DESIGN CB	DRAWN BY CB	DART AEROSPACE LTD HAWKESBURY, ONTARIO, CANADA	
CHECKED LE	APPROVED [Signature]	DRAWING NO. DSI 9373	REV. A SHEET 1 OF 1
DATE 07.03.28	TITLE D3146-4 BRACKET		SCALE NTS
REV A	DATE 07.03.28	DESCRIPTION NEW ISSUE

DART SERVICE INSTRUCTION

TO AMEND INSTALLATION INSTRUCTIONS IIN-D412-694

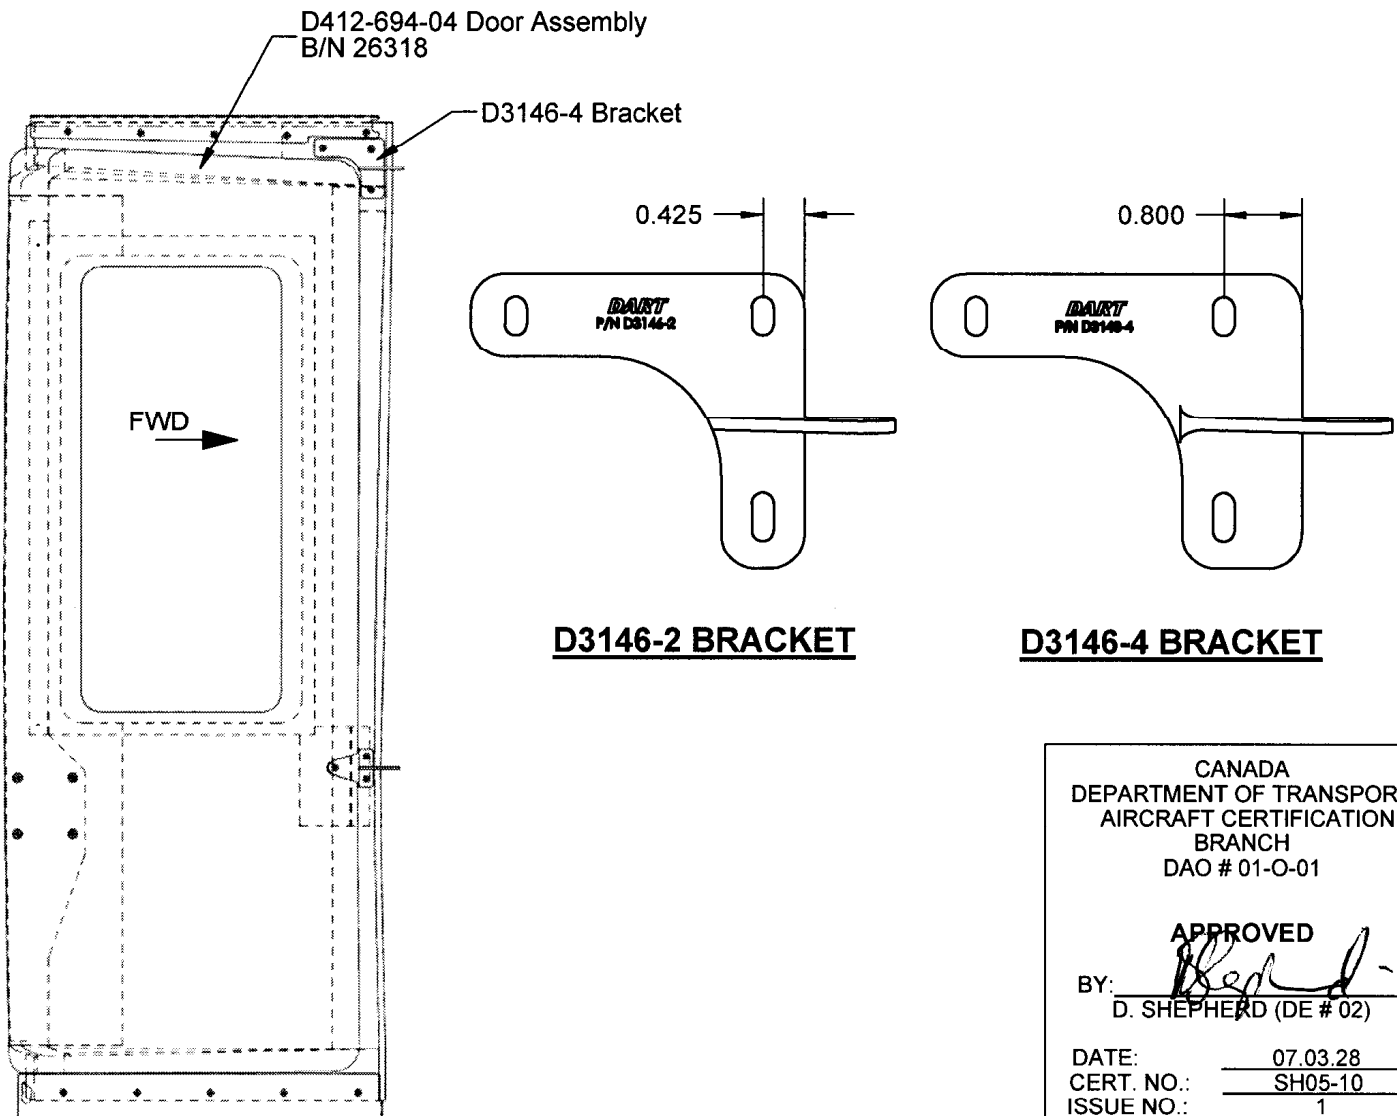
For D412-694-04 Door Assembly B/N 26318, the D3146-2 Bracket that is mounted at the top of the door has been replaced by a D3146-4 Bracket. This D3146-4 Bracket is identical to the D3146-2 Bracket except that it is 0.375" longer than D3146-2 as shown below. This bracket is installed the same way as the D3146-2 Bracket as shown in Installation Instructions IIN-D412-694. The D3146-4 Bracket must be used to ensure the door operates properly.
